Engineering Change Notice(ECN)

ECN-E-2606-06(ECP AP&3D TYPE_PIO CABLE PIN Sequence Change)

FA Research EE team

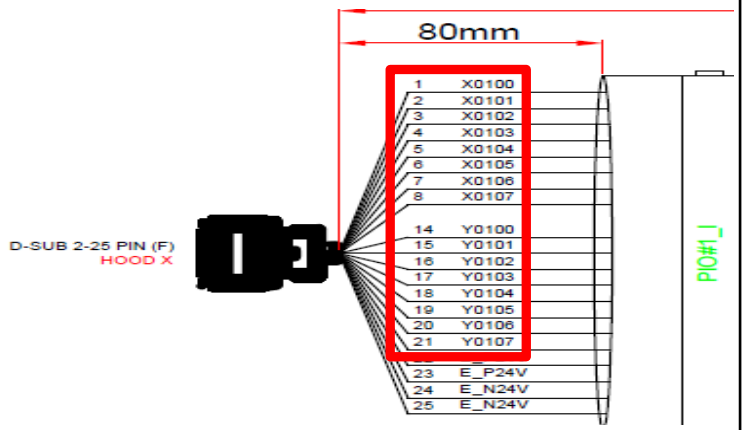
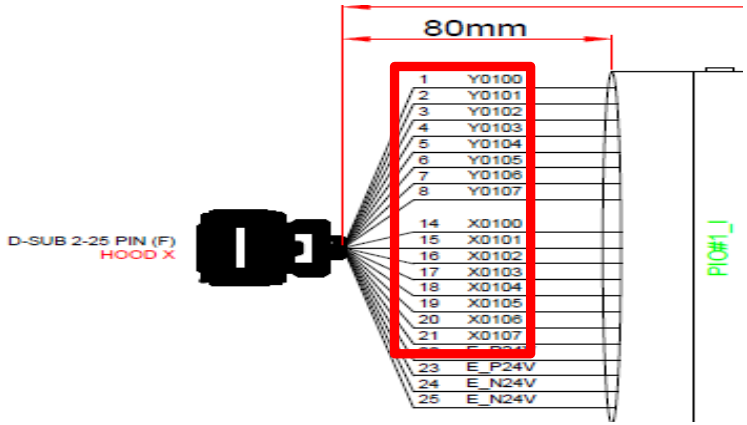
적용 장비 타입 Applicable project type	ECP AP&3D TYPE	적용 범위 Scope	■ 신규 발주분 (New order) □ 기발주분 (Previous order) □ 기출하장비 (Existing shipped equipment)
변경 사유 Reason for change	□ 고객 요청 (Customer request) ■ 품질개선 (Quality improve) □ 원가절감 (Cost reduction) □ 생산성 향상 (Increase productivity) □ 부품 단종 (Part discontinuation) □ 기타 (ETC)	ECR NO.	N/A
		ECN NO.	ECN-E-2606-06
변경 상세 사유 Detailed reason for change	PIO#1~3 Cable 1~8번 PIN과 14~21번 PIN이 뒤바뀌어 DMS 센서 입/출력 신호가 반대로 주고 받는 현상 발생 An issue occurred where PINs 1–8 and PINs 14–21 of the PIO #1–3 cables were reversed, causing the DMS sensor input/output signals to be transmitted and received inversely.		
변경 사항 Changes	변경 전(Before)	변경 후(After)	
	 PIO #1	 PIO #1
상세내용 Detail	1) Previous Dwg No. : EAP-E-I12-7000-0 2) Description : No. 1~8 PIN(X0100~X0107), No. 14~21 PIN(Y0100~Y0107)	1) New Dwg No. : EAP-E-I12-7000-1 2) Description after change : No. 1~8 PIN(Y0100~Y0107), No. 14~21 PIN(X0100~X0107)

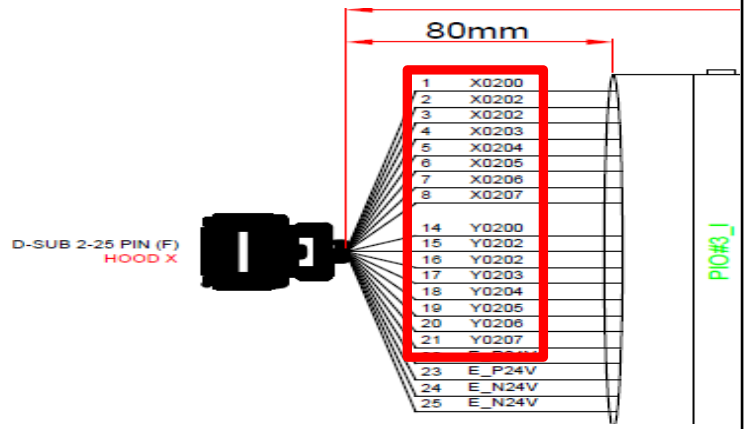
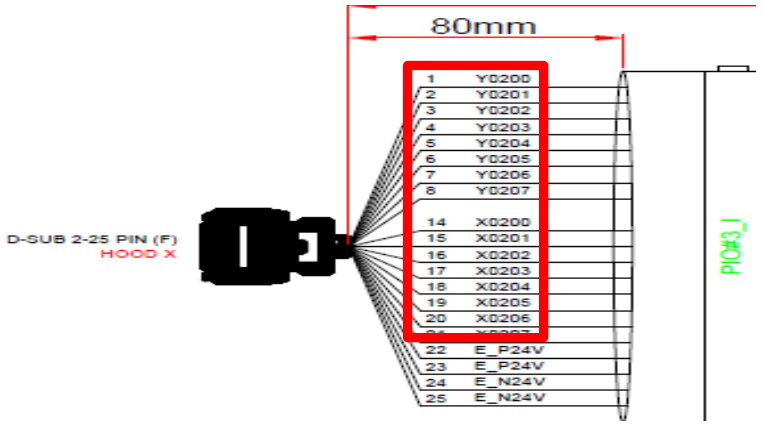
적용 장비 타입 Applicable project type	**ECP AP&3D TYPE**	적용 범위 Scope	■ 신규 발주분 (New order) □ 기발주분 (Previous order) □ 기출하장비 (Existing shipped equipment)
변경 사유 Reason for change	□ 고객 요청 (Customer request) ■ 품질개선 (Quality improve) □ 원가절감 (Cost reduction) □ 생산성 향상 (Increase productivity) □ 부품 단종 (Part discontinuation) □ 기타 (ETC)	ECR NO.	N/A
		ECN NO.	ECN-E-2606-06
변경 상세 사유 Detailed reason for change	PIO#1~3 Cable 1~8번 PIN과 14~21번 PIN이 뒤바뀌어 DMS 센서 입/출력 신호가 반대로 주고 받는 현상 발생 An issue occurred where PINs 1–8 and PINs 14–21 of the PIO #1–3 cables were reversed, causing the DMS sensor input/output signals to be transmitted and received inversely.		
변경 사항 Changes	변경 전(Before)	변경 후(After)	
	 PIO #2	 PIO #2
상세내용 Detail	1) Previous Dwg No. : EAP-E-I13-7000-0 2) Description : No. 1~8 PIN(X0108~X0115), No.14~21 PIN(Y0108~Y0115)	1) New Dwg No. : EAP-E-I13-7000-1 2) Description after change : No. 1~8 PIN(Y0108~Y0115), No.14~21 PIN(X0108~X0115)

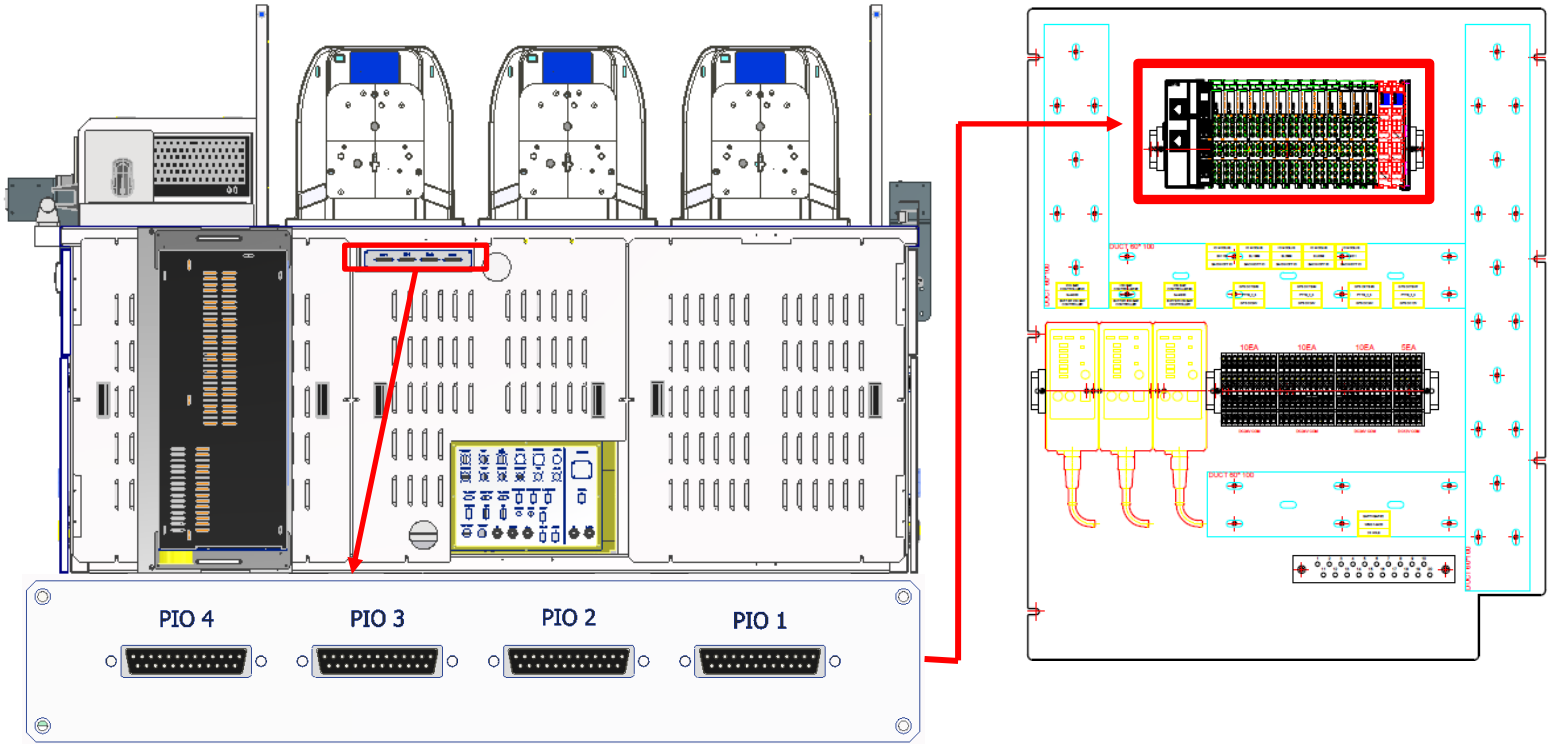
적용 장비 타입 Applicable project type	**ECP AP&3D TYPE**	적용 범위 Scope	■ 신규 발주분 (New order) □ 기발주분 (Previous order) □ 기출하장비 (Existing shipped equipment)
변경 사유 Reason for change	□ 고객 요청 (Customer request) ■ 품질개선 (Quality improve) □ 원가절감 (Cost reduction) □ 생산성 향상 (Increase productivity) □ 부품 단종 (Part discontinuation) □ 기타 (ETC)	ECR NO.	N/A
		ECN NO.	ECN-E-2606-06
변경 상세 사유 Detailed reason for change	PIO#1~3 Cable 1~8번 PIN과 14~21번 PIN이 뒤바뀌어 DMS 센서 입/출력 신호가 반대로 주고 받는 현상 발생 An issue occurred where PINs 1–8 and PINs 14–21 of the PIO #1–3 cables were reversed, causing the DMS sensor input/output signals to be transmitted and received inversely.		
변경 사항 Changes	변경 전(Before)	변경 후(After)	
	 PIO #3	 PIO #3
상세내용 Detail	1) Previous Dwg No. : EAP-E-I14-7000-0 2) Description : No. 1~8 PIN(X0200~X0207), No.14~21 PIN(Y0200~Y0207)	1) New Dwg No. : EAP-E-I14-7000-1 2) Description after change: No. 1~8 PIN(Y0200~Y0207), No. 14~21 PIN(X0200~X0207)
